North Chapel Hill-Novare/Fickling Proposal

Plan Dated June 15, 2021

Plan Comments

Prepared by: Brian Peterson, AIA, Urban Designer, TOCH

Development Review Sketch-Novare/Fickling Proposal

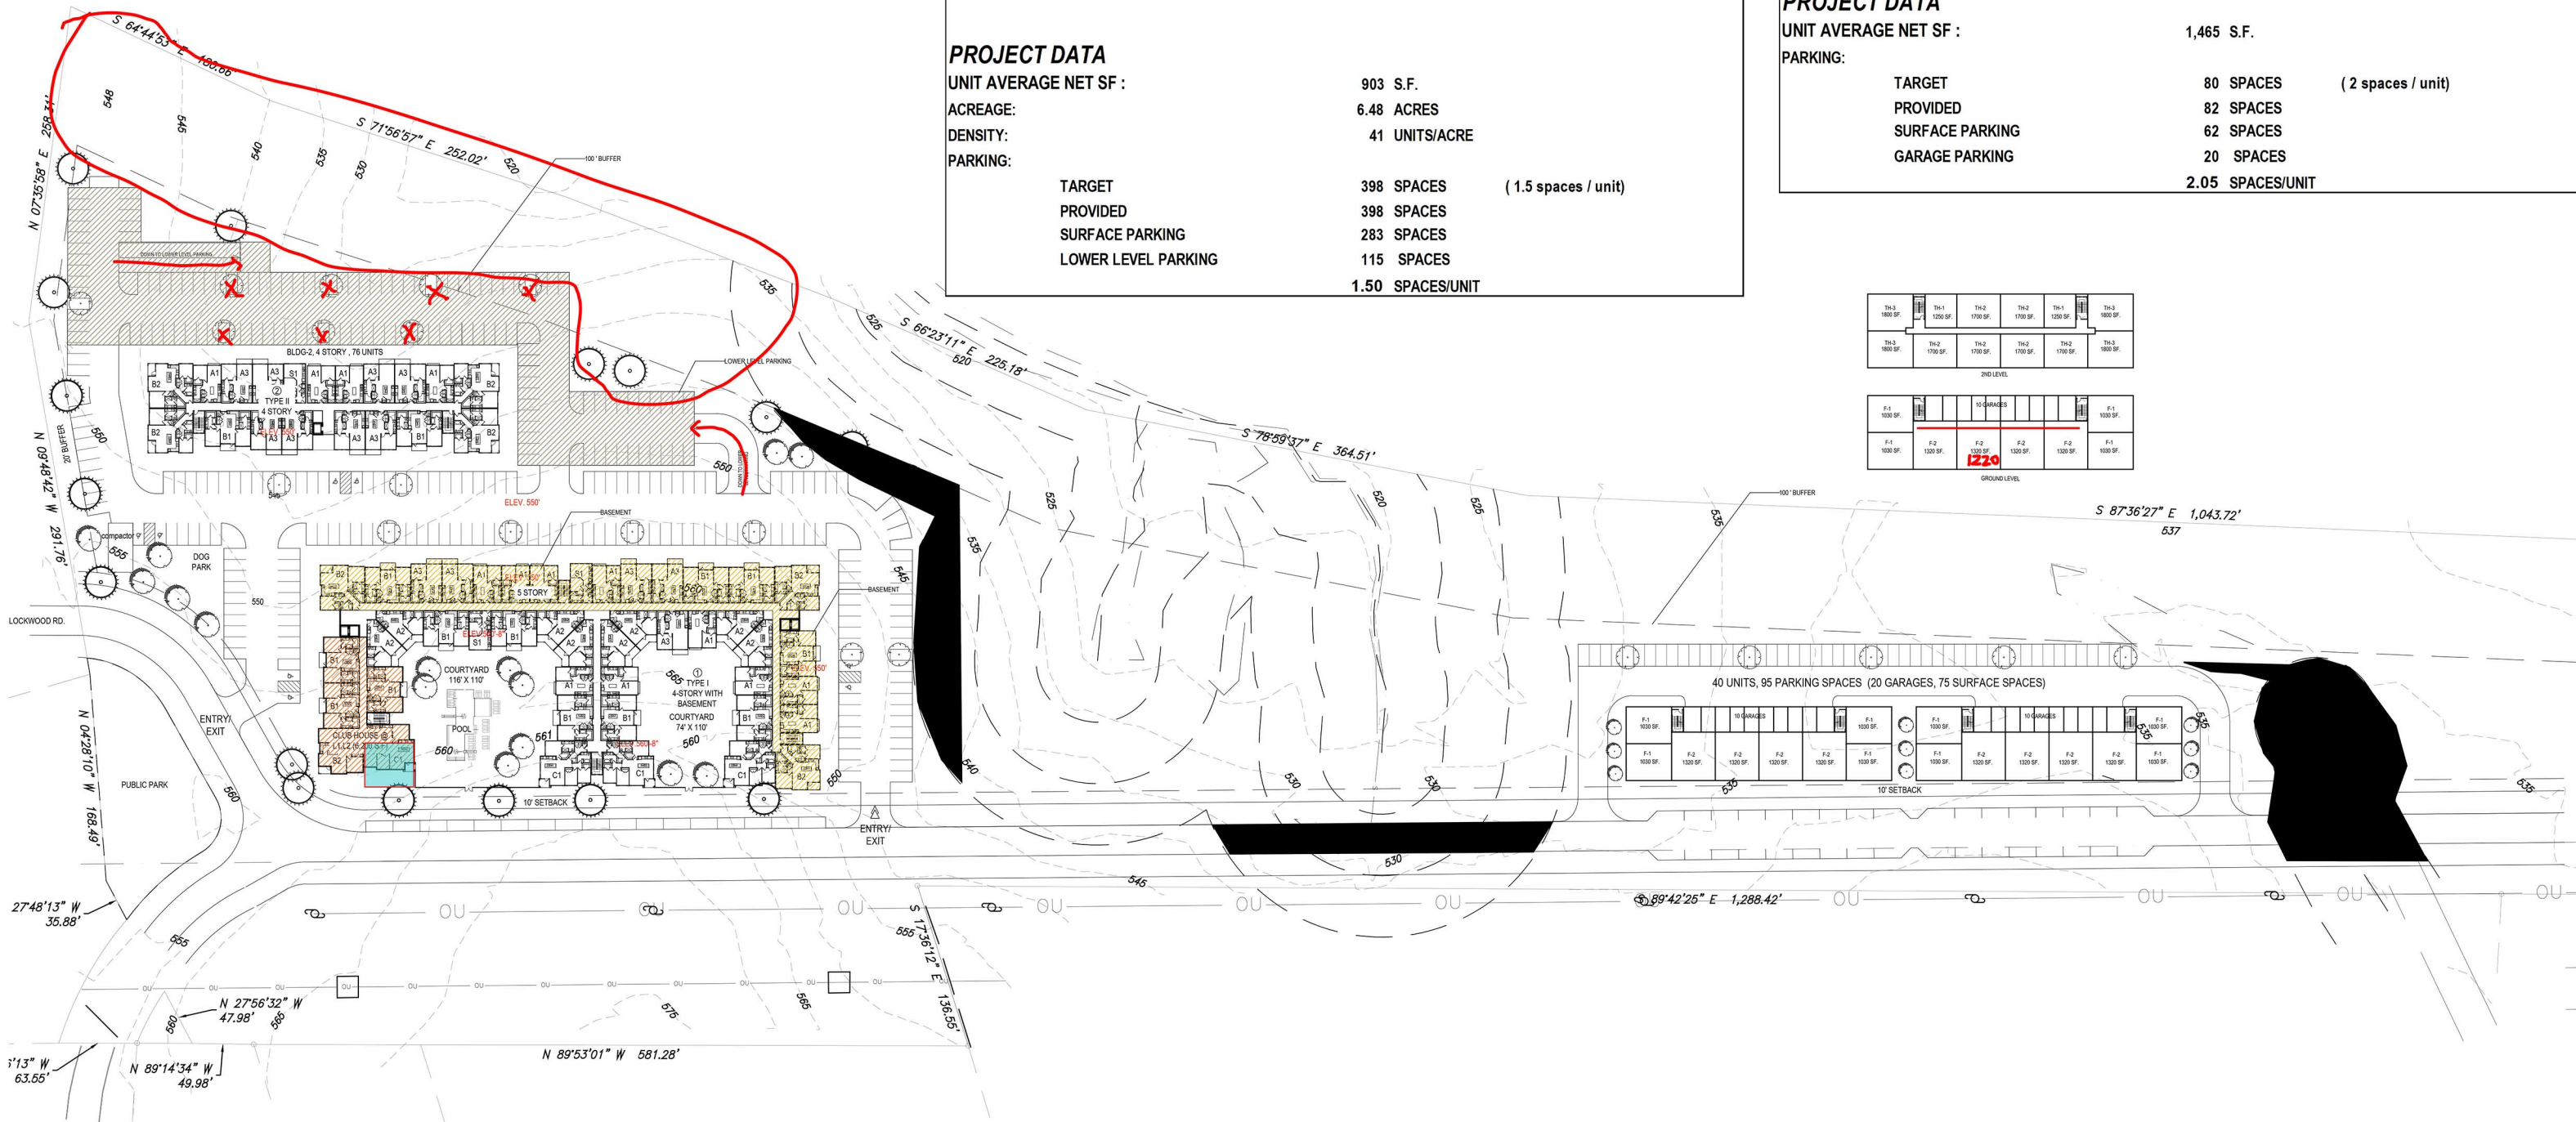
1. Consider changing north building to an "L" shape to better engage this building with the other and to help define a plaza space between the buildings to act as a focal point and gathering area along the extended Lockwood Drive as it enters the property. This plaza should be designed to complement the neighborhood park space across the street. There can still be a vehicular entrance drive but it should look more like a plaza space than a driveway. Fire truck access issues will need to be considered when analyzing this idea.

2. In order to facilitate development integration between this property and the one to the south, consider providing a street stub-out which would eventually extend a road into the neighboring property, to connect to Weaver Dairy Road across from the Timberlyne shopping center access drive.

3. Consider providing a community garden/open space in the area under and around the power lines south of the proposed east/west street. The applicant team will need to discuss this possibility with the utility companies.

4. Provide a greenway extension through this community open space to link with the greenway to the west.
5. Extend the Greenway along the south side of the new east/west street, to eventually extend into the neighboring property to the east. Consider a greenway width similar to the cross section proposed as part of the earlier master planning effort for the parcels (40' wide total frontage from curb to property line, as conditions allow). The north edge of the main east/west street should have an urban quality, with a tree planting strip, street trees, and a sidewalk. There will be occasional parallel parking along this street adjacent to residential areas.

6. A large RCD/storm water detention area has been identified. Consideration should be given to make this area some kind of an amenity for the neighborhood (nature areas, trails, etc.)

7. The current plan of this building has the pool courtyard facing the south, toward the street. Suggested turning this courtyard to face the north, away from the street.

8. The other courtyard, still facing the street, can act as a terminus to the view corridor when approaching from the future street extension to Weaver Dairy, and could contain some small gathering spaces. The terminus view feature could alternatively be accomplished architecturally, with a tower or other focal feature on the building. Providing stoops and individual unit entrances was encouraged for the ground floor residential areas in the courtyard and along the street frontages.
